American Telecommunications Certification Body Inc.  
6731 Whittier Ave, McLean, VA 22101

RE: Accton Technology Corporation

FCC ID: HEDSMC2536WAG2

After a review of the submitted information, I have a few comments on the above referenced Application. Depending on your responses, kindly understand there may be additional comments.

DFS

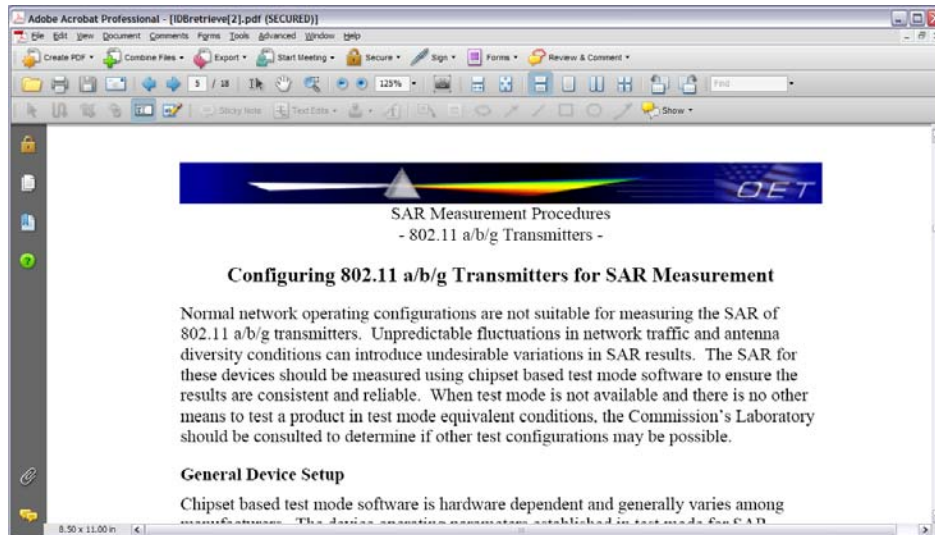
- 12) The report states this is a client without ad-hoc capability (5250-5350 MHz). Recent FCC KDB cites a separate cover letter attestation needs to be included (from the applicant). Please see: <http://fjallfoss.fcc.gov/oetcf/kdb/forms/FTSSearchResultPage.cfm?id=34859&switch=P>

Note: Users manual suggests unit is capable of ad-hoc modes. Note that these modes can not be allowed in the 5250 – 5350 MHz band. Please review (manual page 12).

- 13) Users manual shows that part of installation allows selection of region/country. Devices subject to DFS do not allow for this to occur as selection of alternative region will cause device to be non-compliant and not allowed under 15.15 of the rules unless application is submitted as a software defined radio (SDR) which may only be done in a filing directly with the FCC (page 11 of manual).
